Magnolia Public Schools

Regular Board Meeting & MPS Board Retreat

Approval of Construction and Contractor Change Orders for the Magnolia Science Academy-5 (7111 Winnetka) Project

Re: Magnolia Science Academy 5 Project – Increment #2, Del Amo Construction
Prime Contract Change Order 033

RFI #082: Perforated Panels Structural Steel Horizontal Beam Alignment Clarification

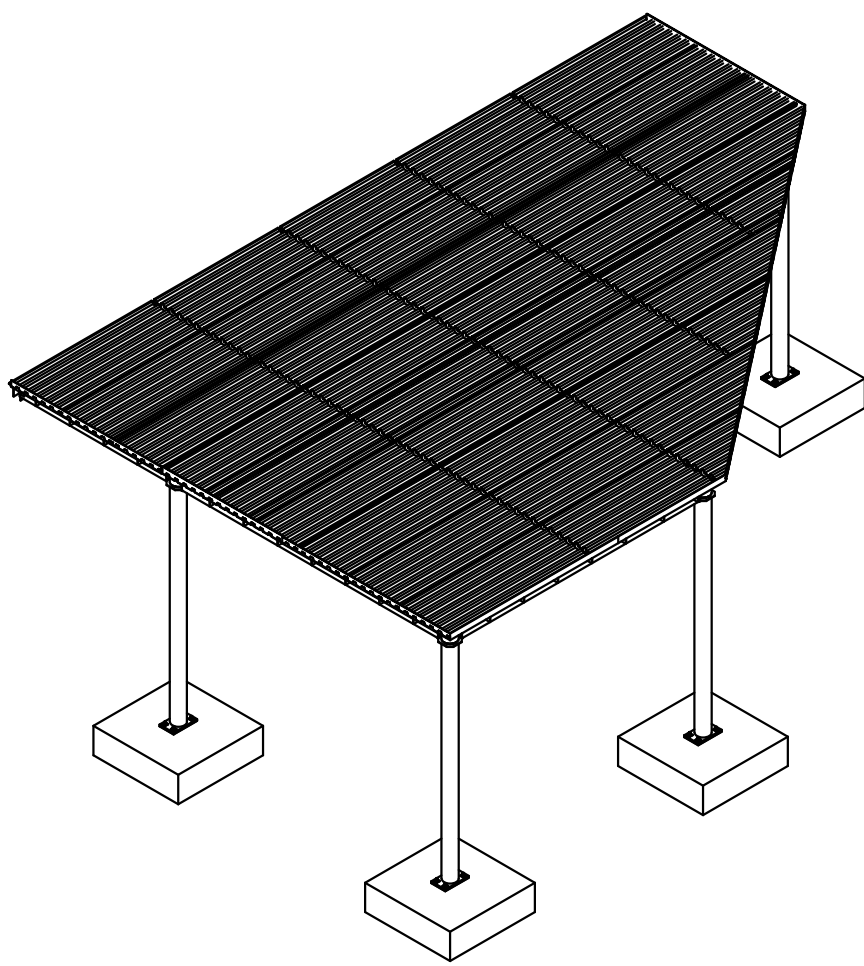
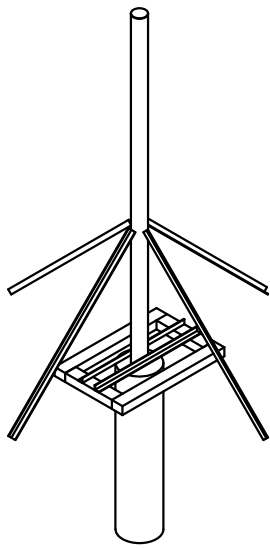
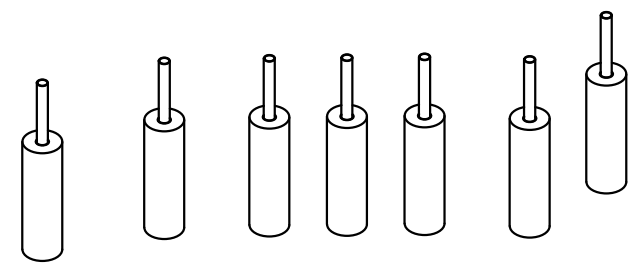
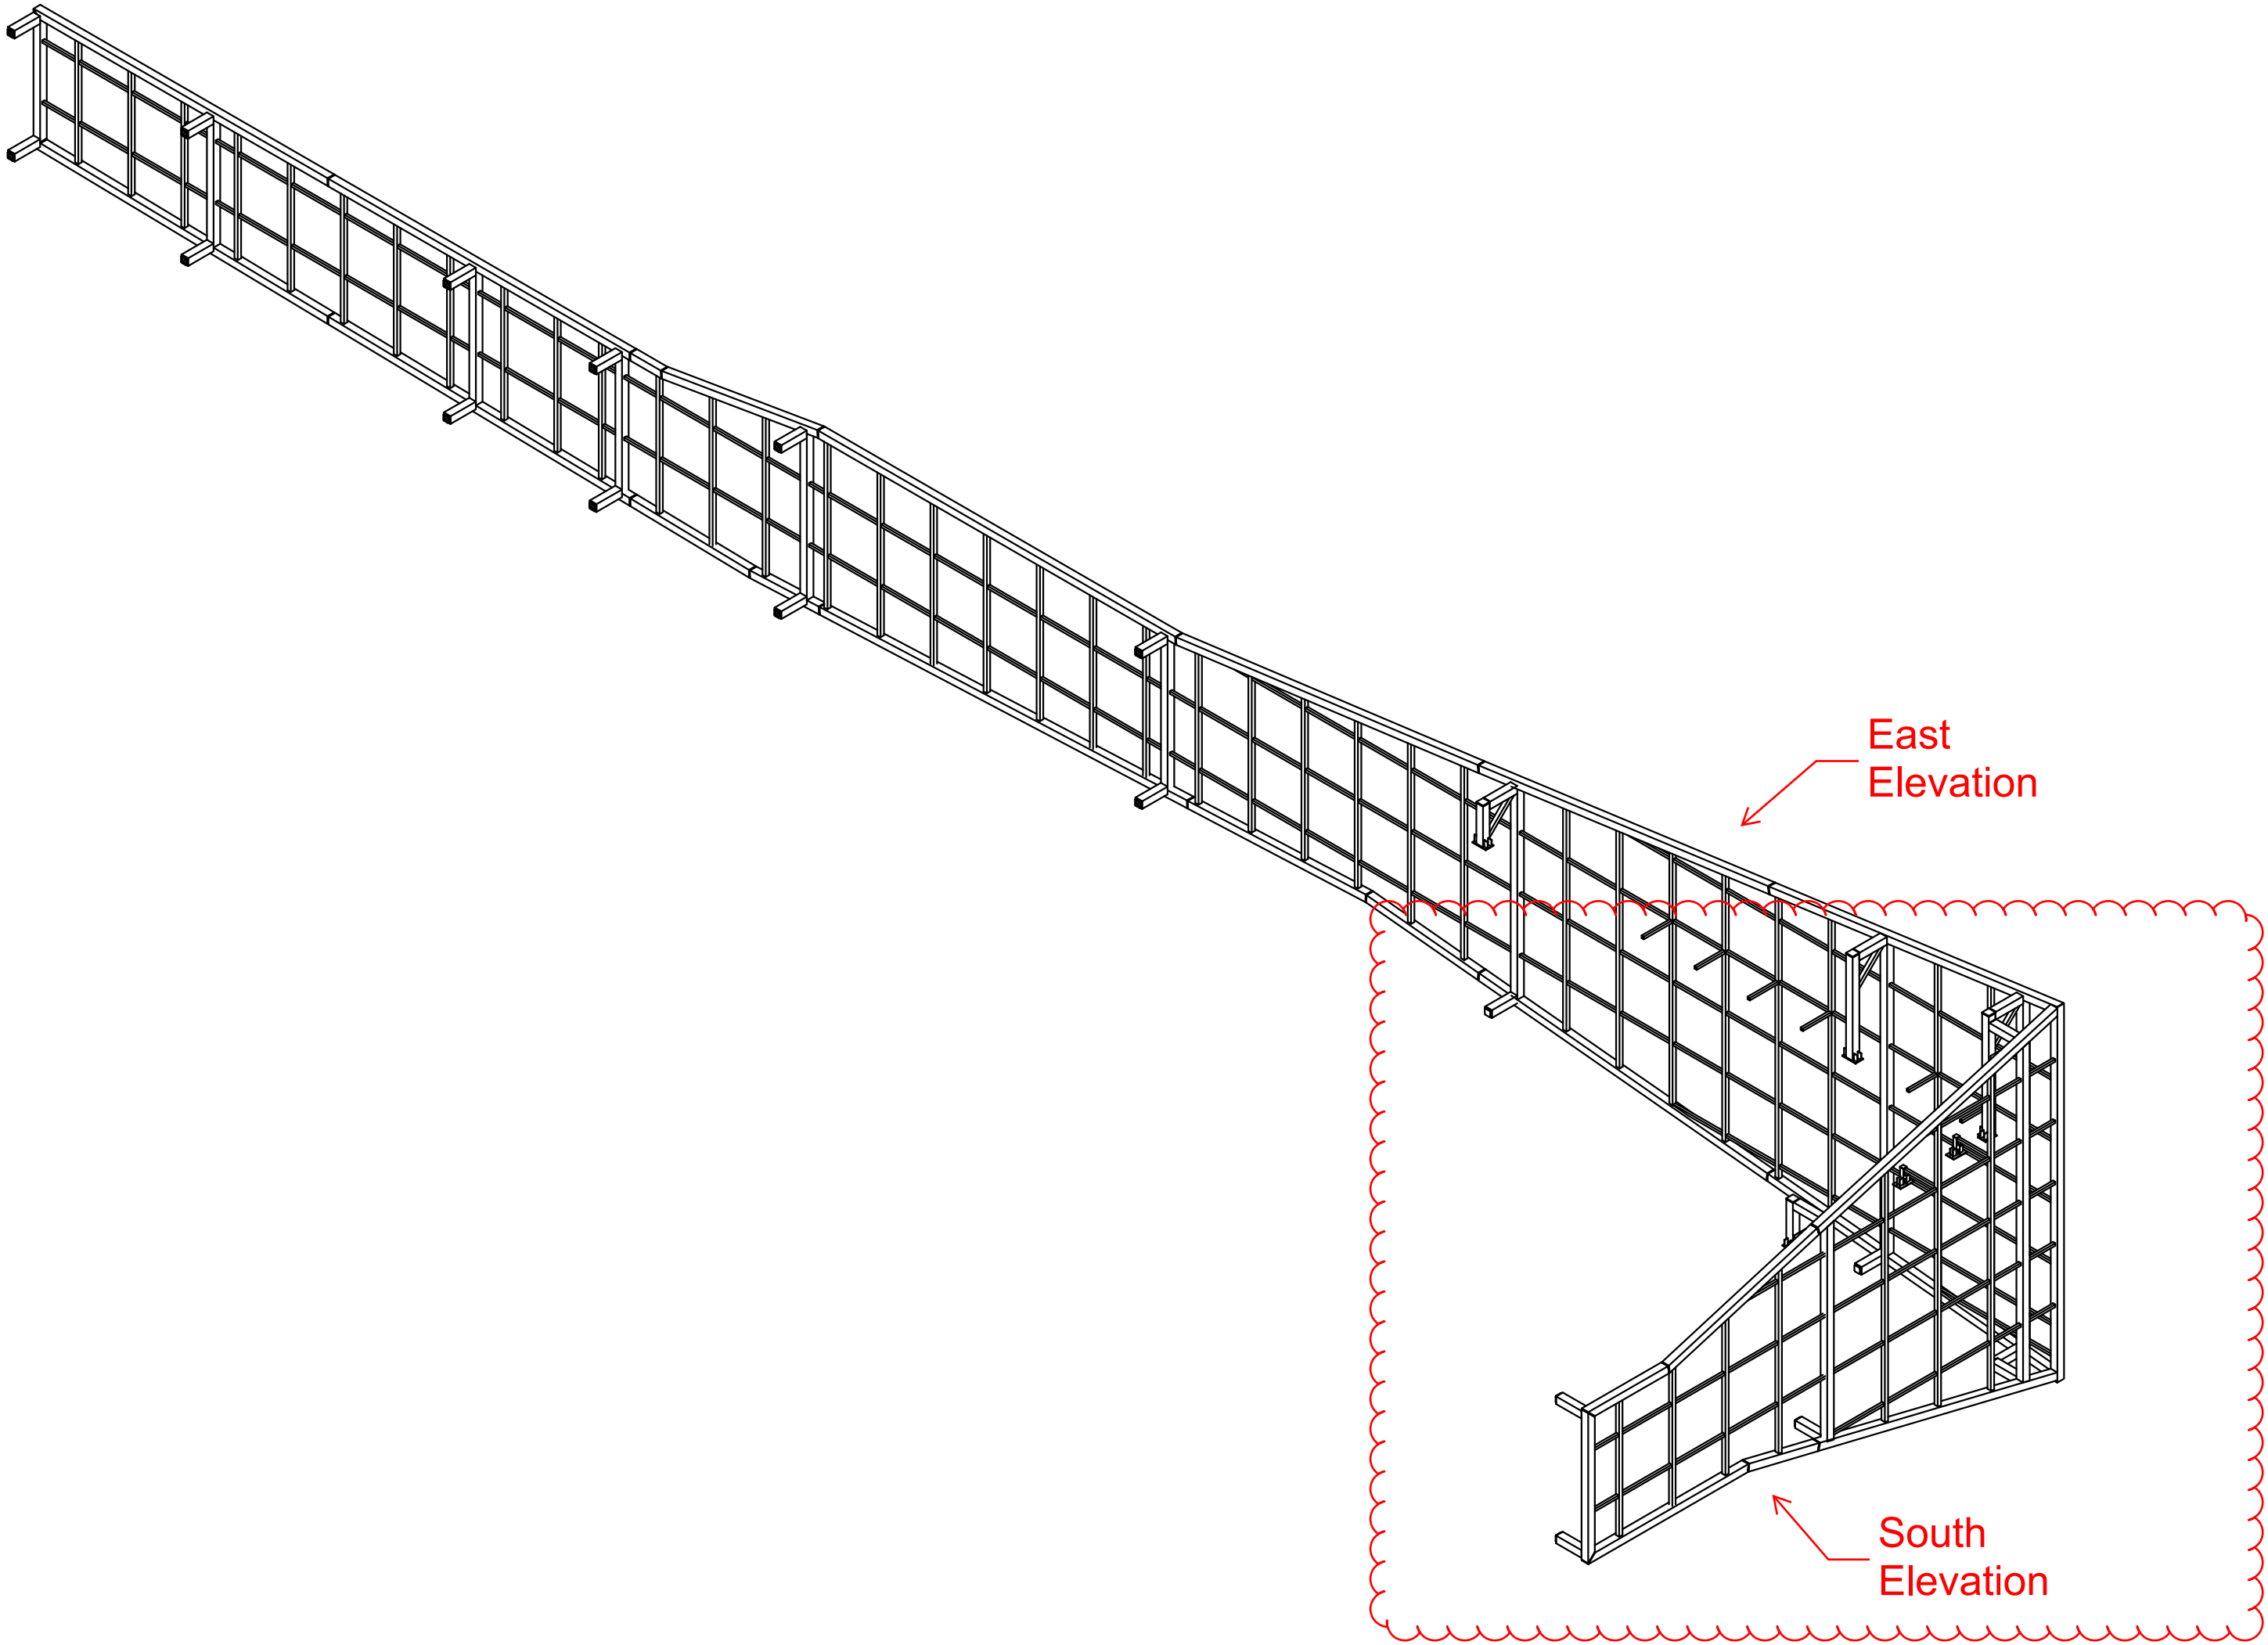
Following a review of the structural steel shop drawings by Premier Steel Structures, it was identified that the horizontal beams on the South Elevation are not aligned with those on the East Elevation.

To address this, Best Contracting and Premier Steel propose lowering the horizontal beams on the South Elevation to achieve alignment with the East Elevation, thereby providing continuous structural support.

It is confirmed with Premier Steel that fabrication of the South Elevation beams have not begun and this adjustment can still be performed.

Screen Frame Alignment: Design of horizontal beams on south elevation did not align with those on east elevation. DAC subcontractors proposed lowering horizontal beams on south elevation to achieve alignment. RFI 82 confirmed this direction. Cost includes additional shop work and material.
